City of Portland, Oregon
Bureau of Development Services
Land Use Services

NOTICE OF A TYPE II_x DECISION ON A PROPOSAL IN YOUR NEIGHBORHOOD

CASE FILE NUMBER: LU 13-214934 LDS

**EXISTING CONDITIONS, TREE SURVEY
AND TENTATIVE PLAN
FOR PROPOSED SUBDIVISION
"CRAUN ESTATES"
1S2E09DD TAX LOT 03000
PER DOCUMENT NO. 2006-057230**

CASE NO. 13-214934
EXHIBIT C-1

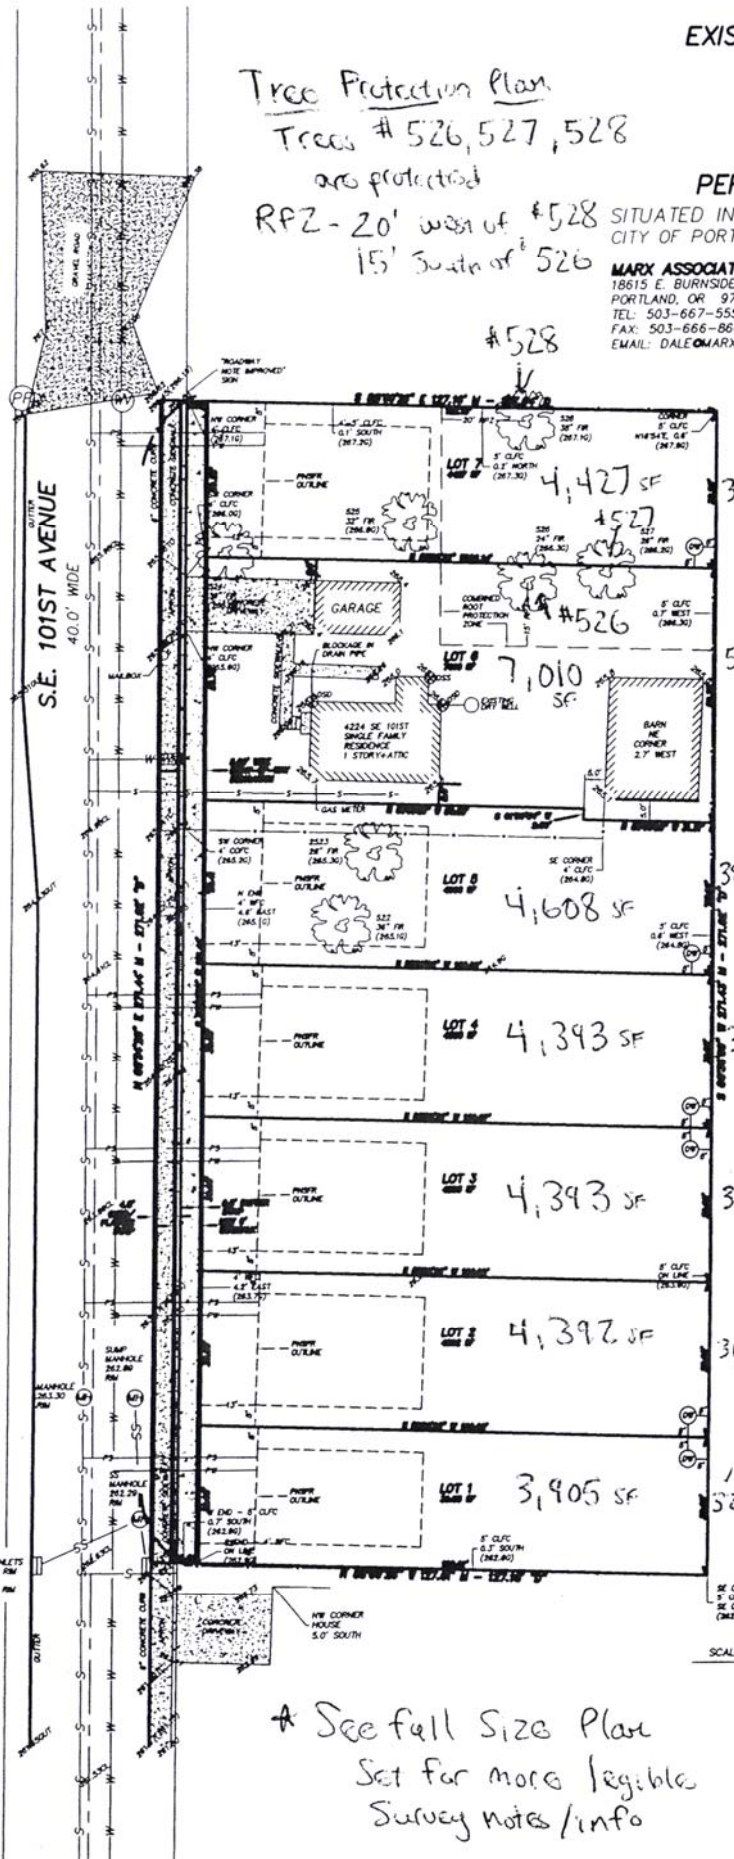
- The applicant has demonstrated, with Exhibit C-1 that the narrow lot will be built with a house that is 22 feet in width and will be able to accommodate a garage that will occupy no more than 50% of the length of the street facing façade. The garage limitation standards of Subsection 33.110.253.E can be met.

The total non-exempt tree diameter on the site is 223 inches. The applicant proposes to preserve trees 526, 527, and 528 which comprise of 88 inches of diameter, or 39 percent of the total non-exempt tree diameter. This proposal complies with Option 1 of the tree preservation standards, which requires at least 35 percent of the total non-exempt tree diameter on the site to be preserved. The trees to be preserved and the required root protection zones are shown on the applicant's Tree Preservation Plan/Preliminary Land Division Plan (Exhibit C.1).

This criterion is met, subject to the condition that development on Lots 6 and 7 be carried out in conformance with the Tree Preservation Plan/Preliminary Land Division Plan (Exhibit C.1) and the applicant's arborist report (Exhibit A.2) and an Acknowledgement of Tree Preservation Requirements is recorded with the final plat.

1. Development on Lots 6 and 7 shall be in conformance with the Tree Preservation Plan (Exhibit C-1) and the applicant's arborist report (Exhibit A-2). Specifically, trees numbered 526, 527, and 528 are required to be preserved, with the root protection zones indicated on Exhibit C-1. Tree protection fencing is required along the root protection zone of each tree to be preserved. The fence must be 6-foot high chain link and be secured to the ground with 8-foot metal posts driven into the ground. Encroachment into the specified root protection zones may only occur under the supervision of a certified arborist. Planning and Zoning approval of development in the root protection zones is subject to receipt of a report from an arborist, explaining that the arborist has approved of the specified methods of construction, and that the activities will be performed under his supervision.
